# UNITED STATES PATENT AND TRADEMARK OFFICE

**Office Action Summary**

1. The following correspondence is a non-final Office Action for application number 10/523,926, for a VIBRATION ISOLATING PIPE CLIP, filed on 2/7/2005. Claims 1-20 have been cancelled. Claims 21-43 are pending. Claim 43 is withdrawn pursuant to a restriction requirement.

**Fig. 2**

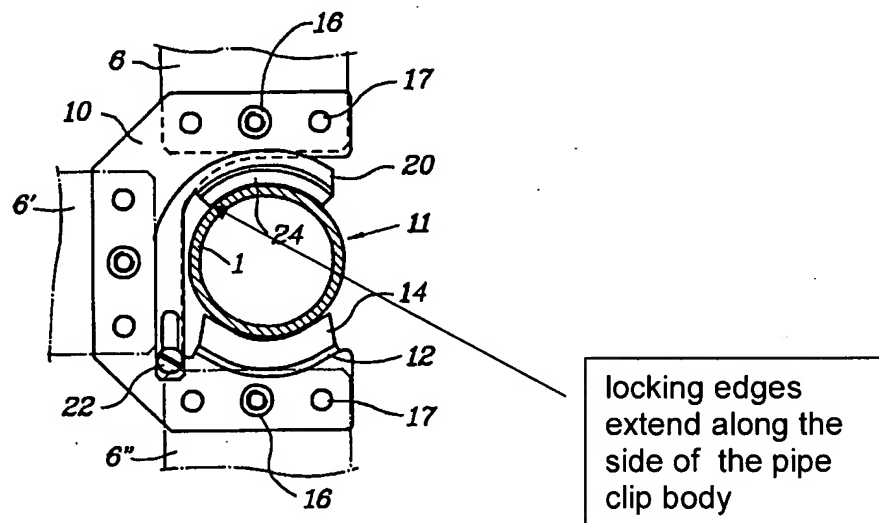
Regarding claims 37 and 38, Gerster and van Walraven teach the pipe clip of claim 36, and, as best understood Gerster teaches that the vibration isolating member is provided with retaining edges that extend along the side edges of the pipe clip body and interact with the pipe clip body in a positively locking manner (Fig. 2) (see below).
